ZONING CHANGE REVIEW SHEET

CASE: C814-2023-0027 (311-315 South Congress PUD)

ADDRESS: 311, 313, and 315 South Congress Avenue

Re: Update 2 Comment Response: 311-315 South Congress PUD – Planned Unit Development (“PUD”) application for the property located at 311-315 South Congress Avenue in Austin, Travis County, Texas (the “Property”).

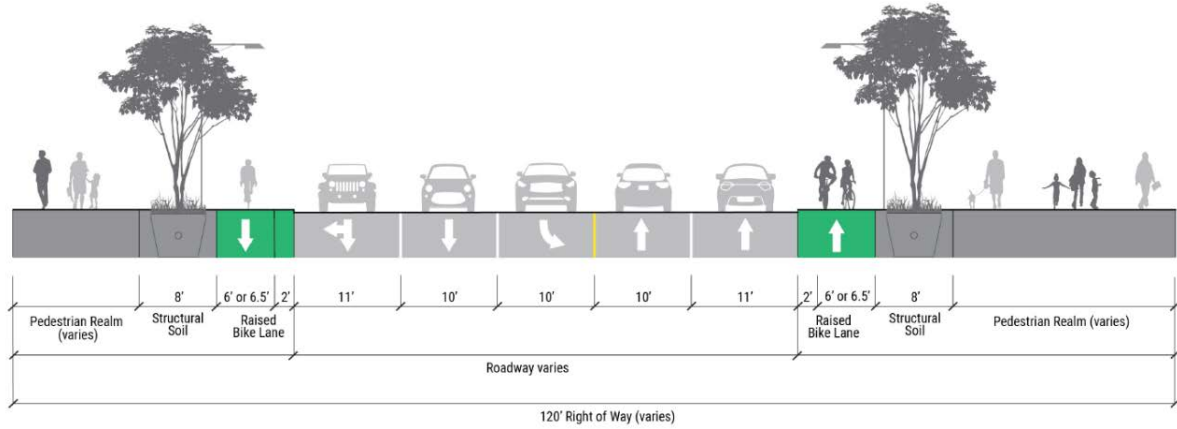
ATD 7. ATD does not recommend approval of this proposed language of Land Use Plan note #8 (noted above). To provide superiority for the streetscape, we request that the site adhere to the streetscape standards as depicted within the proposed in the South Central Waterfront Plan:

S. Congress: The South Central Waterfront plan calls for a 6’-6.5’ raised bike lane behind a 2’ buffer along the east frontage of S. Congress. The ASMP identifies protected bicycle facility along Congress frontage as well. In order to meet the superior results expected from PUDs, the cross sections should at least meet the baseline set by ASMP.

U1: Comment cleared.

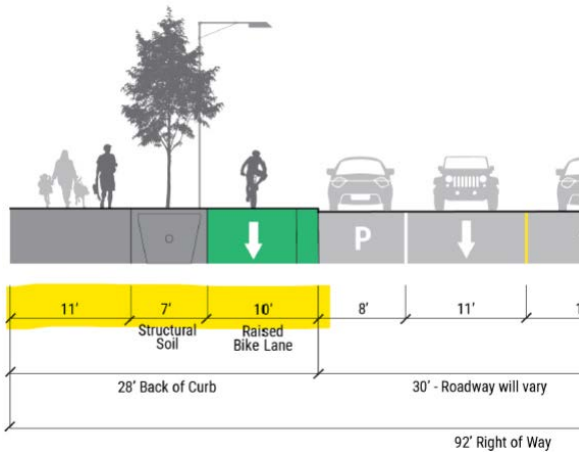
Barton Springs Road: The South-Central Waterfront plan calls for an 11’ pedestrian zone and 8’ planting zone, adjacent to an 8’ raised bike lane behind a 2’ buffer along the southwest frontage of the Barton Springs Road extension. In order to meet the superior results expected from PUDs, the site’s frontage along the Barton Springs extension should provide these streetscape elements as depicted below:
